**CITY OF MANZANITA**

**PLANNING COMMISSION MEETING**

Re: Design review, Manzanita Deli

**CITY OF MANZANITA PLANNING COMMISSION  
FINDINGS OF FACT AND CONCLUSIONS**

3 PERSPECTIVE- CORNER

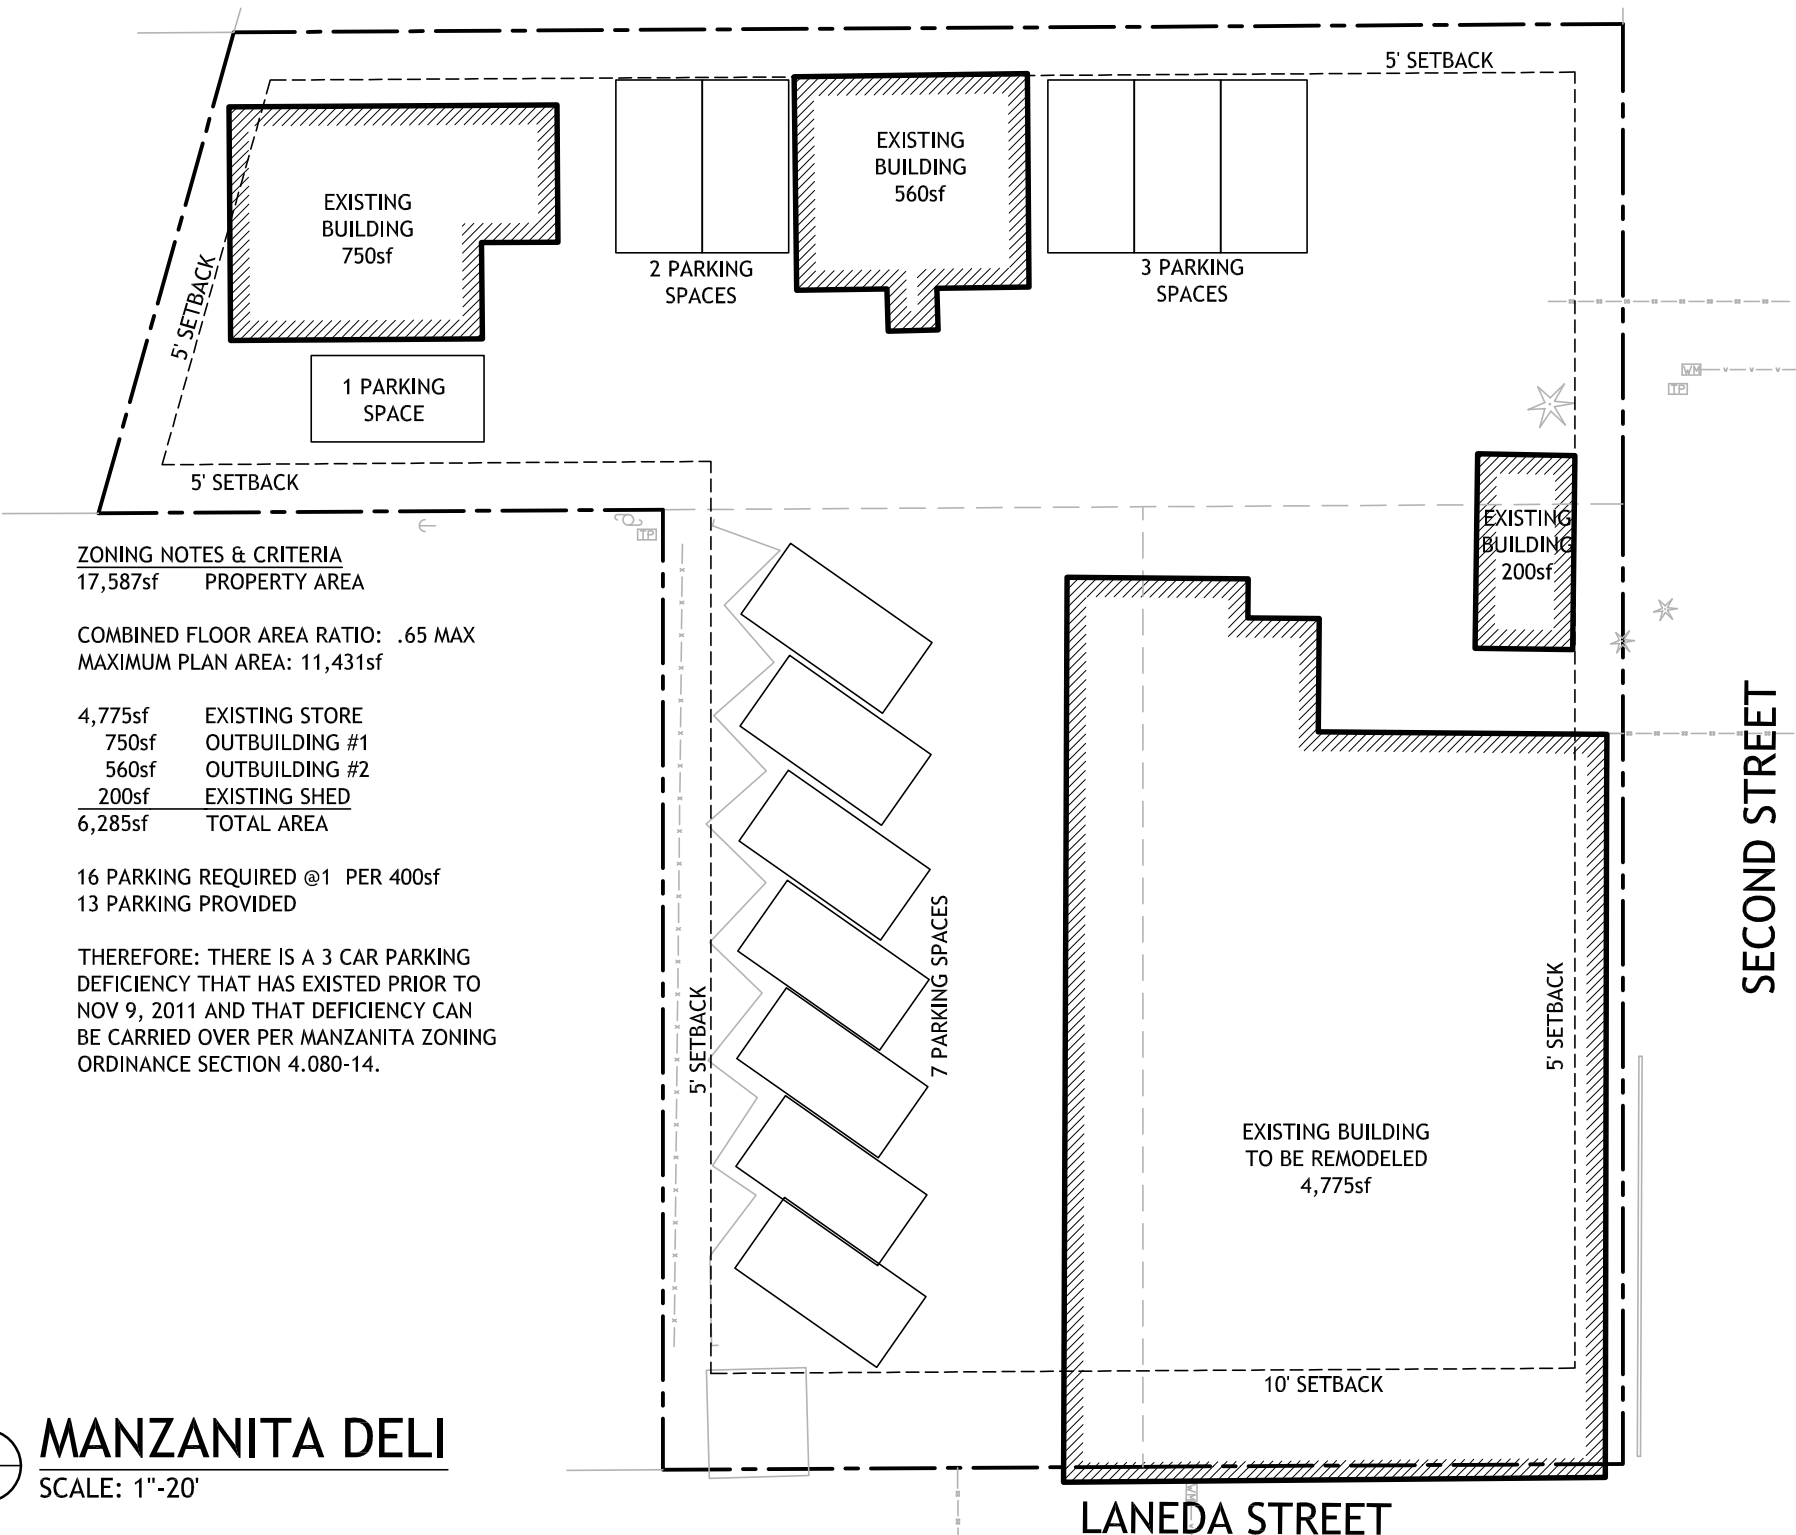
**Findings:** The floor plan shows a gross area of 7,890 square feet. This would require 20 parking spaces ( $7,890/400=19.7$ ).

The proposed site plan shows the required 17 parking spaces.
